## ADDENDUM TO THE WIRING DIAGRAM FOR OIL-FIRED CAST IRON HOT WATER BOILERS

1003041 Rev. 0, March, 2004

## **BOILERS WITHOUT TANKLESS COIL AND HONEYWELL L8148A AQUASTAT CONTROL**

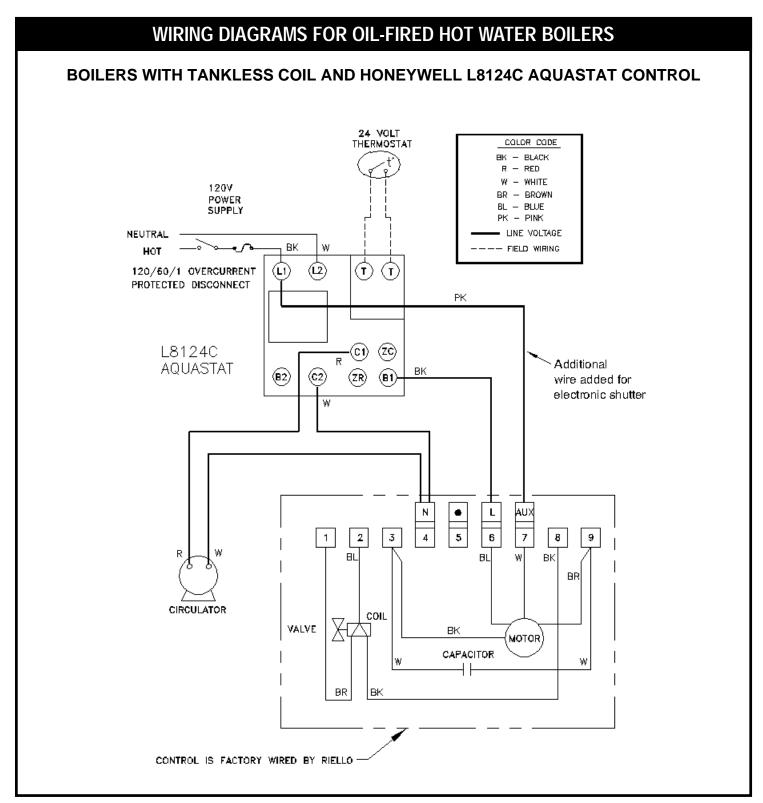
The Wiring Diagrams in the Installation Manual, for the Riello Burner have been modified due to an improvement in the Burner. The burner was modified such that it now utilizes an electronic shutter instead of hydraulic. This required an additional pink wire to be added connecting auxiliary to high voltage. The diagrams in this addendum are to be used in place of those in the following installation Manuals: #14683006 rev 1, #14683456 rev 1, #14683454 rev 1, #14683606 rev 1, and #19878.
